Informal document No. GRE-65-21
(65th GRE, 28-31 March 2011,
agenda item 10)

Proposal to correct ECE/TRANS/WP.29/GRE/2011/28

Note: The text reproduced below was prepared jointly by the experts from GTB and the Society of Automotive Engineers (SAE) in order to correct the proposed light source category D7S, as proposed by SAE to GRE in document GRE/2011/28. The proposal is an administrative change of the light source category name from D7S to D8S. This document has to be seen as a correction to document ECE/TRANS/WP.29/GRE/2011/28 in the sense that only the proposed category name is changed from D7S to D8S. The modifications to the current text of Regulation No. 99 are marked in bold characters.

Figure 1
Category **D8S** - Cap PK32d-1

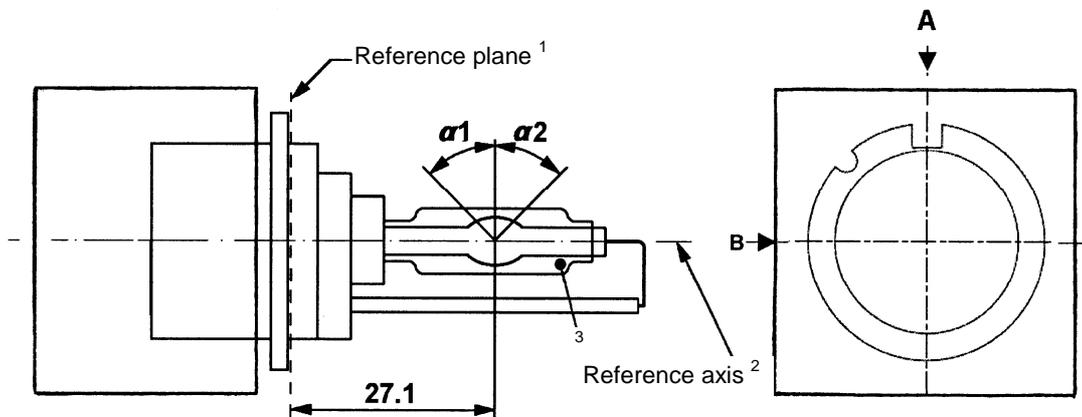
Insert new sheets D8S/1 to 5 after D6S/5, to read:
